CITY OF PORTLAND, MAINE  
Department of Building Inspection

# Certificate of Occupancy

LOCATION 548 Island Ave

RE: 548 Island Avenue  
CBL: 092-A-001

RE: Stevenson glazing

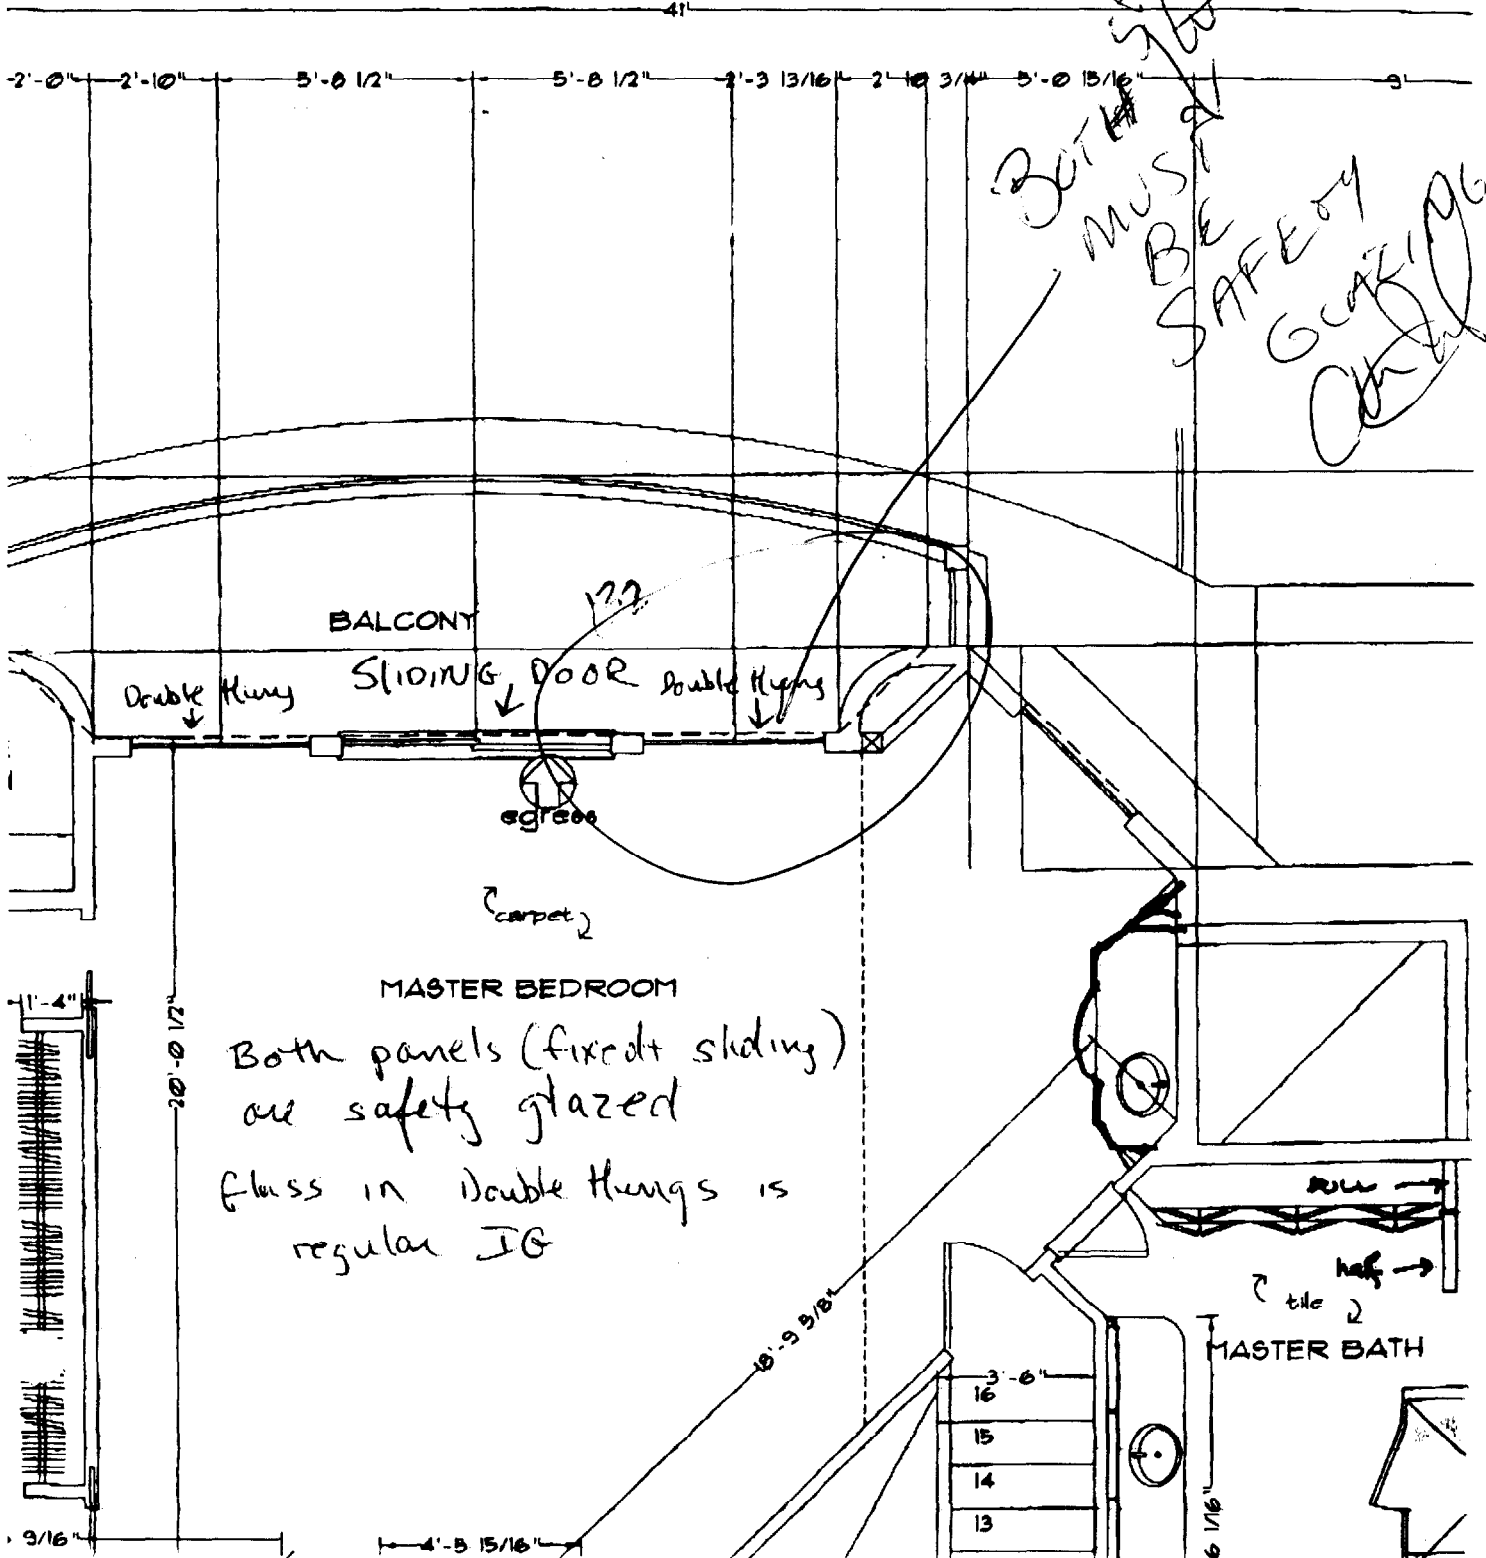
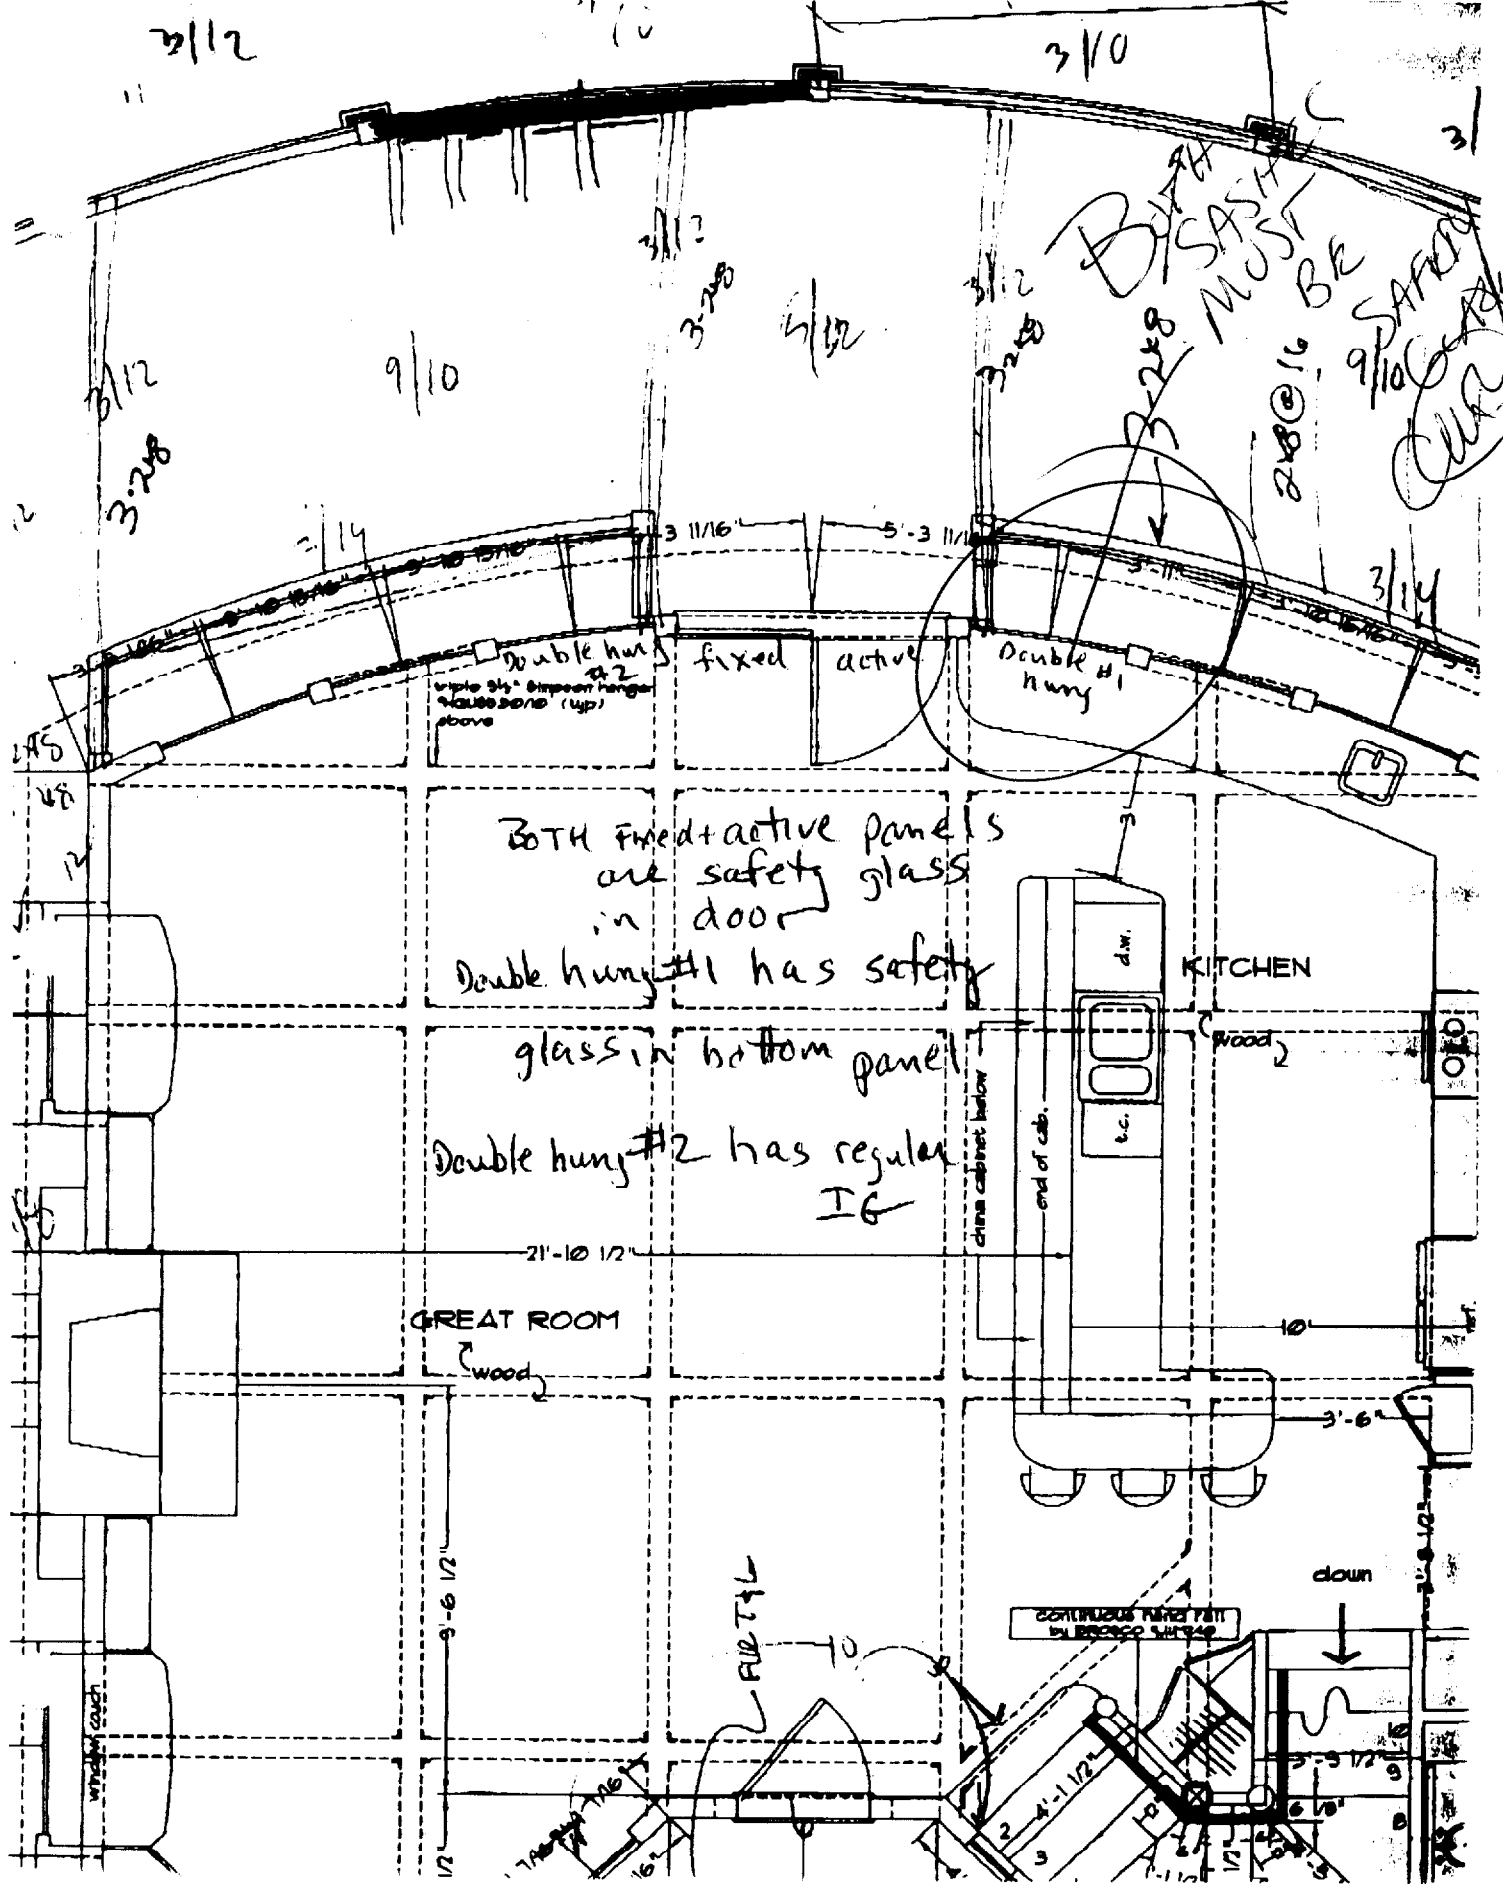
Mike - Sorry for being confusing.

With the attached plan I have illustrated what we spoke about via phone. I was not sure about windows adjacent to sliding doors (non-swinging) + fixed panels

Please find attached Section 2406.2 of the BOCA code and associated commentary. The fixed panel of a slider or swinging patio door must have safety glazing in the event of a slip or mistake. Please advise if this answers your question and feel free to contact me to discuss this matter.
